# **ATTACHMENT 5**

RE: Preliminary Plan #1-06010  
Rock Creek Woods

Re: Rockville High School – Rock Creek Woods  
 (Preliminary Plan #1-06010, Site Plan #8-06007)

**RE: Park and Natural Resources Issues involved in plan 1-06010 and 8-  
06007, Rock Creek Woods**

Pathway  
Alignment

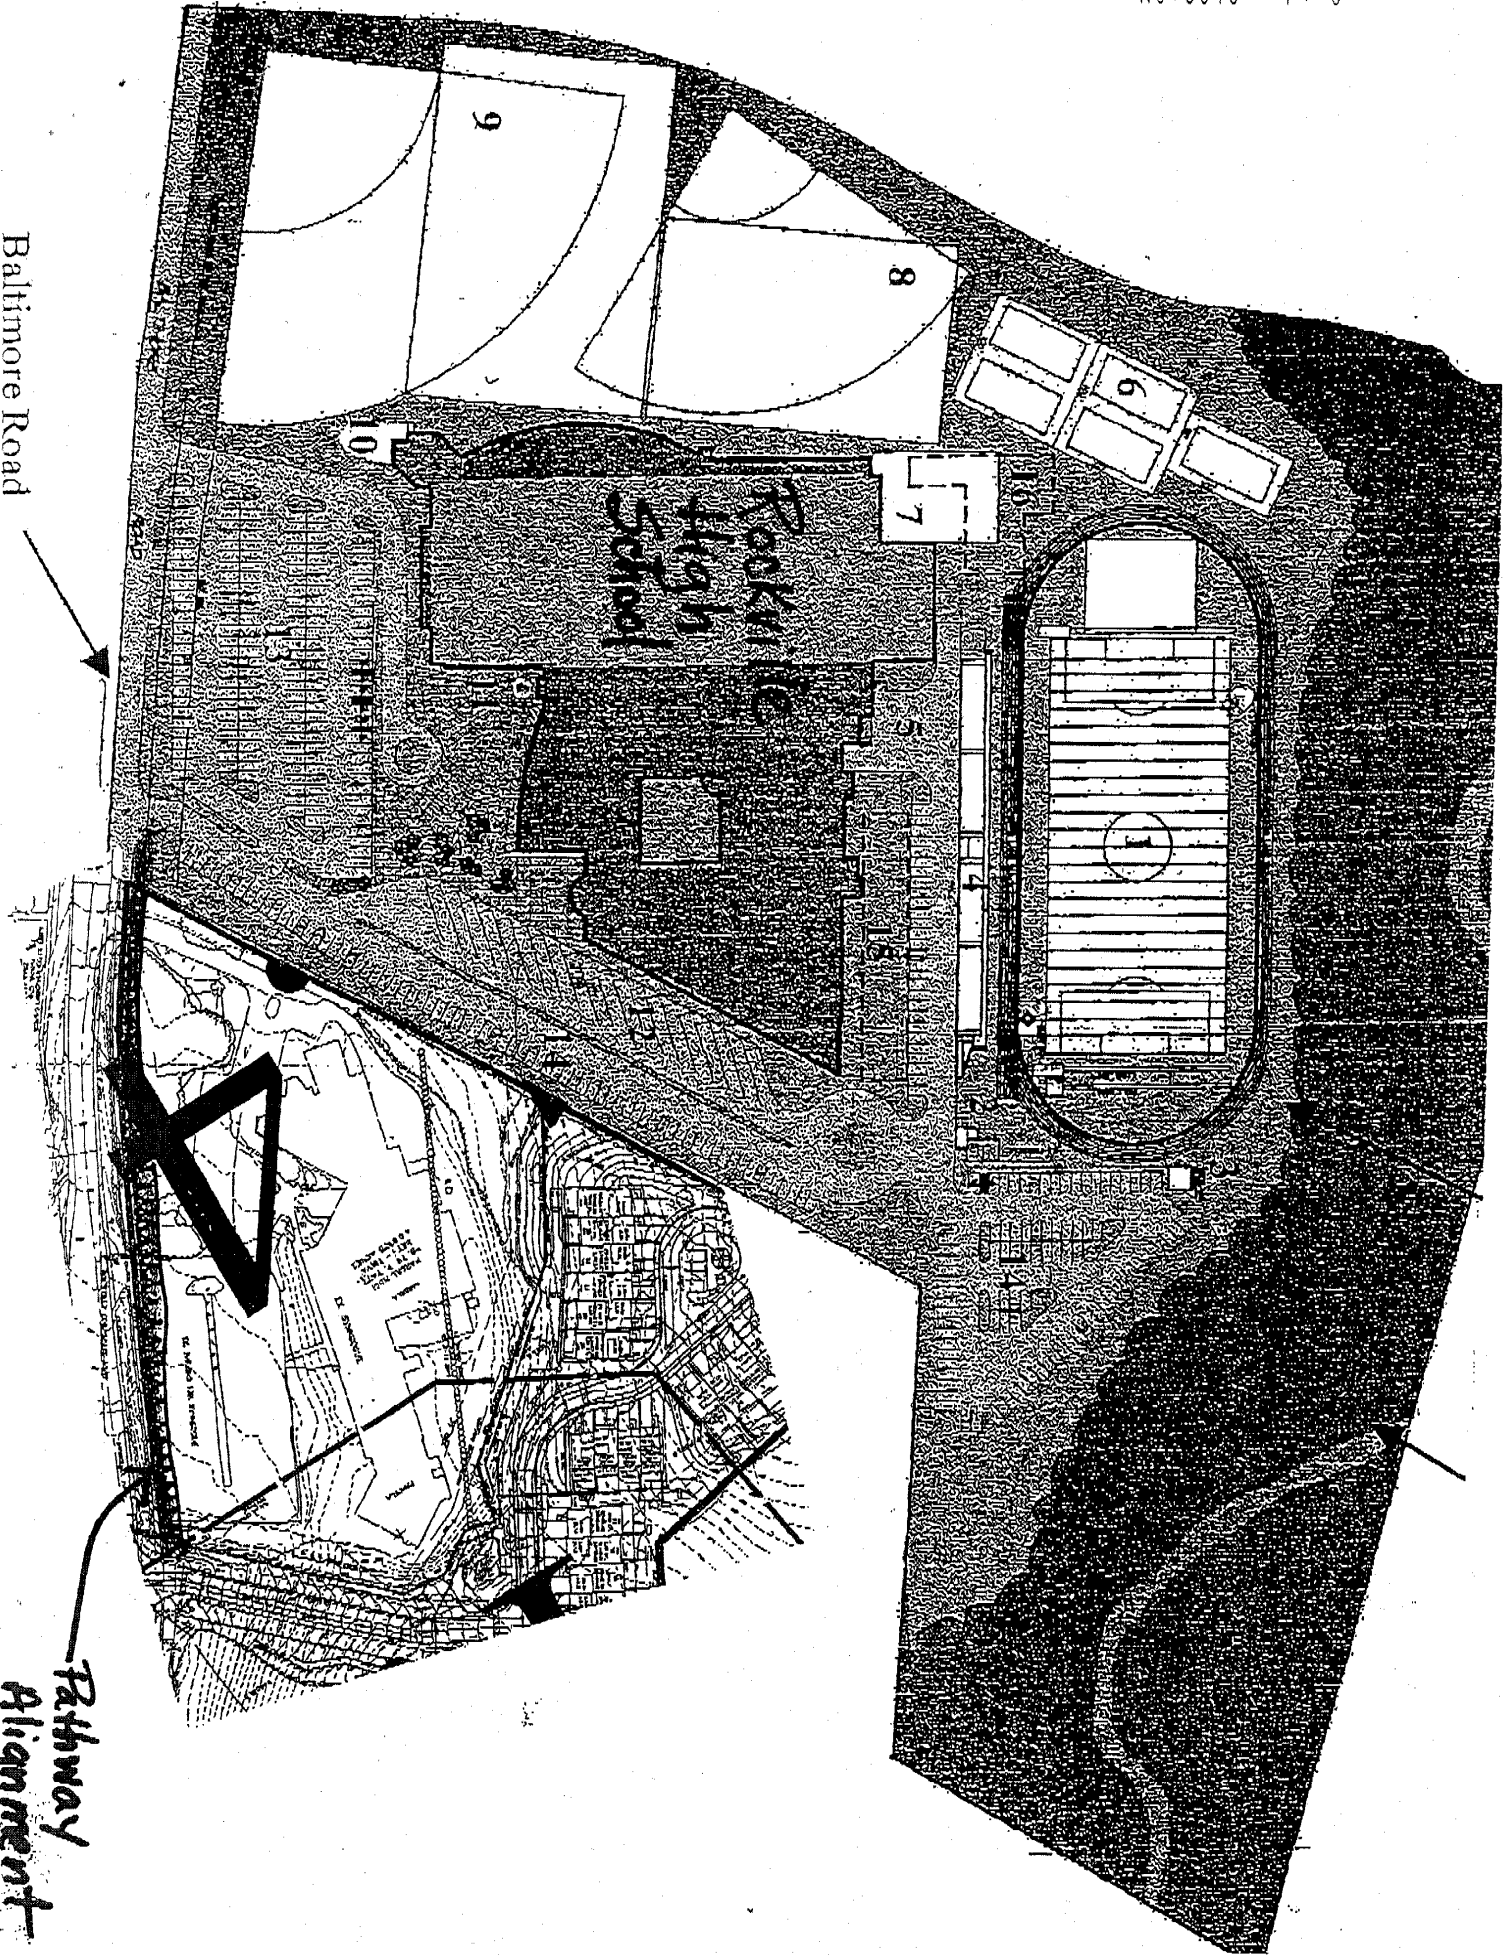
This is to comment on the referenced preliminary and site plans that were presented to the Development Review Committee on September 12, 2005. We request that as a condition of Preliminary and Site Plan approval, the Applicant provide adequate pedestrian connection from the proposed subdivision entrance road to the Rockville High School driveway. Montgomery County Public Schools will grant the necessary right of entry to allow the continuous connection. A drawing is attached that shows the preferred connection highlighted in red.

**Rock Creek Woods**

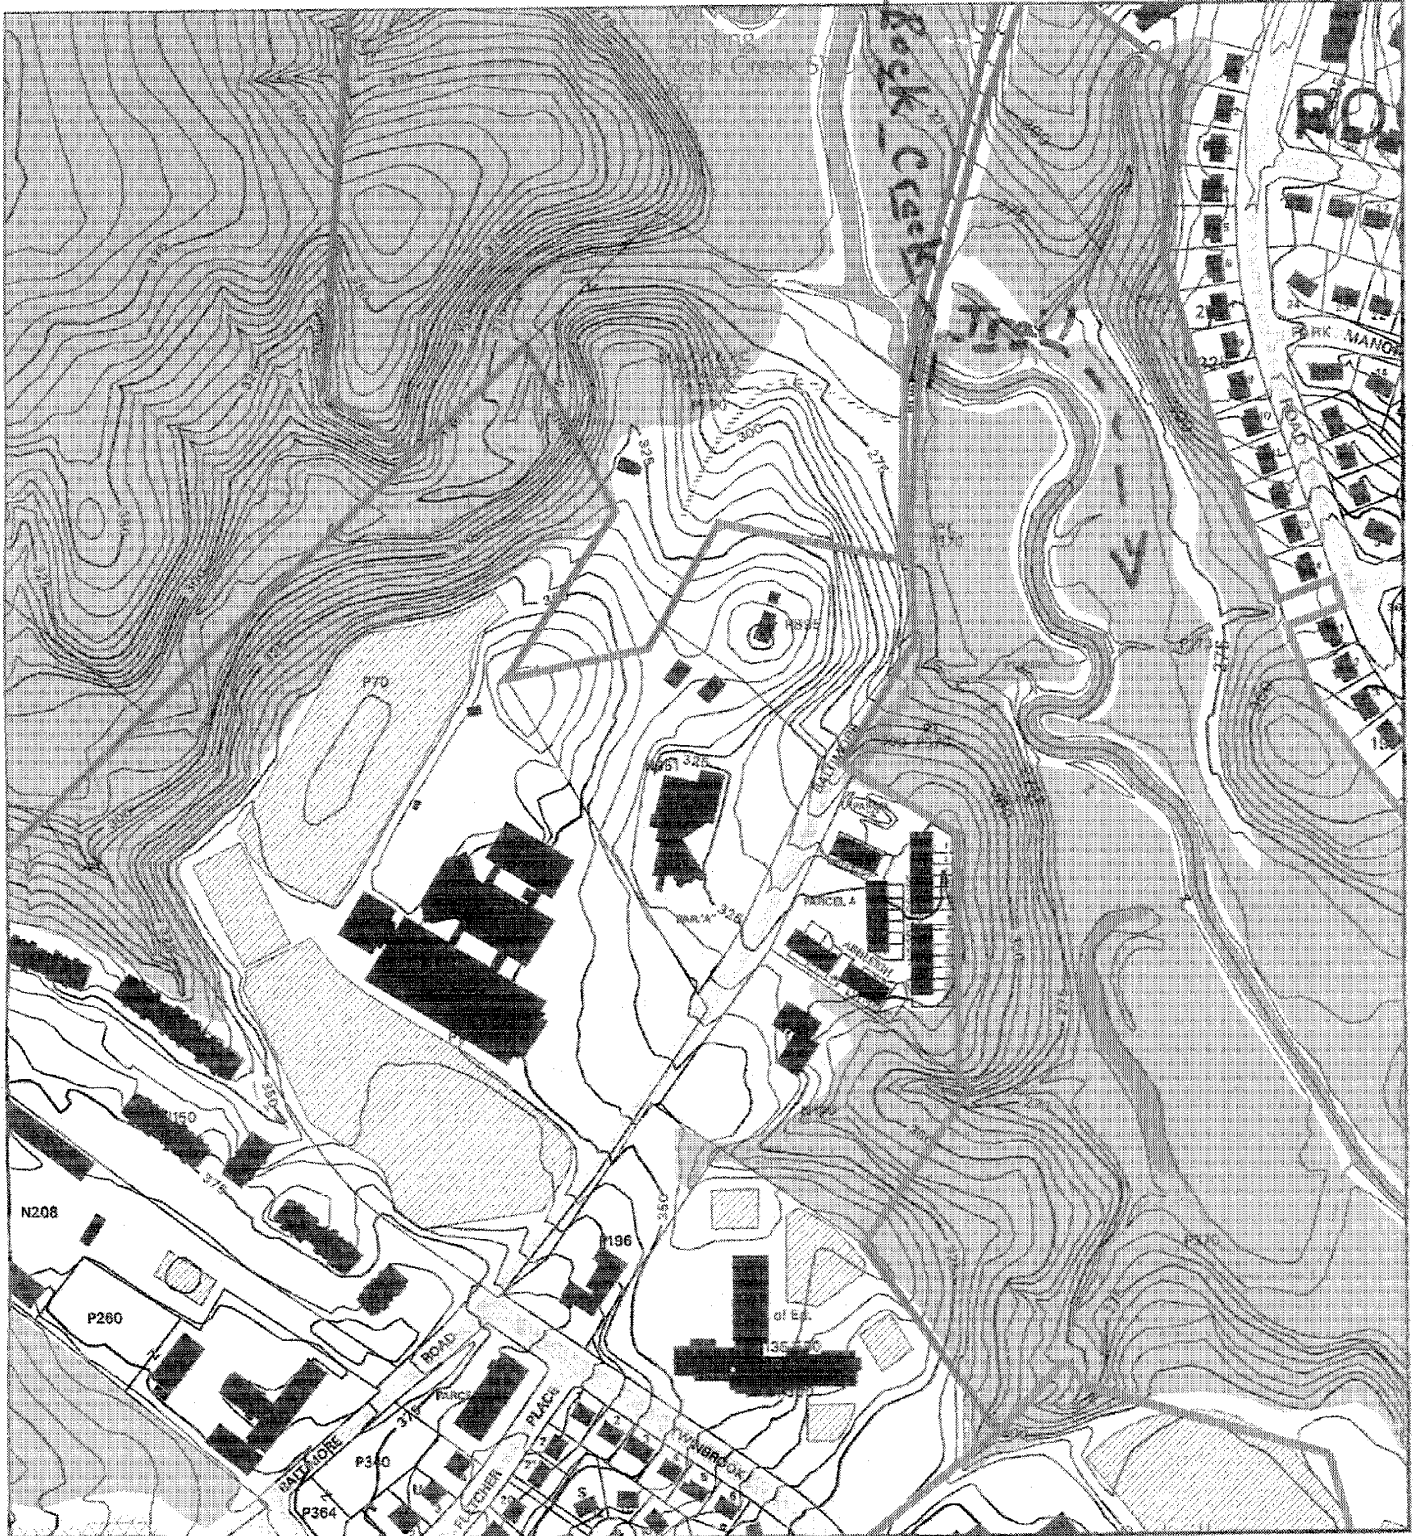
- Construction of 8' wide hard surface trail on east side of Old Baltimore Road to provide pedestrian connection from the development to the Rock Creek hiker/biker trail along Rock Creek located to the north of the property.
- Provide Public Use Trail easement(s) to provide connection to parkland to the northwest of the property. Construct 4' wide natural surface trail within the easement.
- Prevent disturbance to parkland and parkland trees. Provide tree save plan to avoid damage to trees along the adjacent parkland.
